DEVELOPMENT APPLICATION ASSESSMENT REPORT

DA2021/1408

Responsible Officer:	Maxwell Duncan
Land to be developed (Address):	Lot 2 DP 325220, 16 Addison Road MANLY NSW 2095 Lot LIC 30003605, 16 Addison Road MANLY NSW 2095
Proposed Development:	Demolition works and construction of a dwelling house including a boatshed.
Zoning:	Manly LEP2013 - Land zoned C4 Environmental Living

Image 1 - Survey Confirmation of height poles

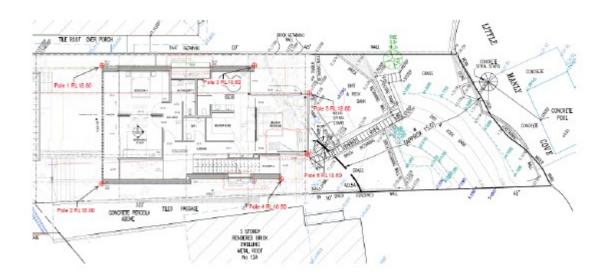
Amended plans and survey confirmation from a registered surveyor confirming the height poles location and heights were lodged with Council. (Refer to plan prepared by Norton Survey Partners dated 21 December 2021).

The location of the height poles (amended) is shown below:
